UNITED STATES PATENT AND TRADEMARK OFFICE

APPLICATION NO.	FILING DATE	FIRST NAMED INVENTOR	ATTORNEY DOCKET NO.	CONFIRMATION NO.
09/529,374	04/12/2000	HANS-BERTH KLERSY	3933.002	6961

Office Action Summary

FIG. 1

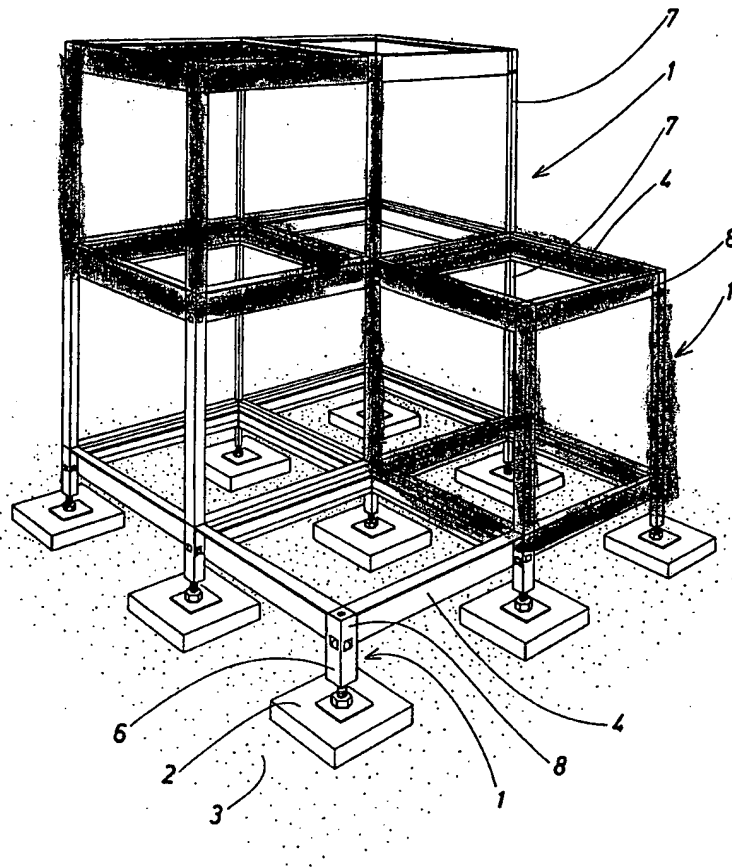
In response to the applicant's argument that ANDERSON does not disclose the use of a finished modular 3-D frame, as defined earlier, a module is a series of standardized units for use together as a unit of architecture or furniture. The modules of ANDERSON are colored in red, see the marked attachment. ANDERSON also discloses that the building includes exterior walls,

windows and doors, column 7, line 57-64. Further, the structure of ANDERSON is a modular unit in that the series of elements (i.e. the floor/ceiling (4), pillar sections (6,7), transverse bearer (21,25), pins (18,20), gussets (36) and exterior finishings are all assembled to form a module, as previously indicated in red, see the marked attachment.
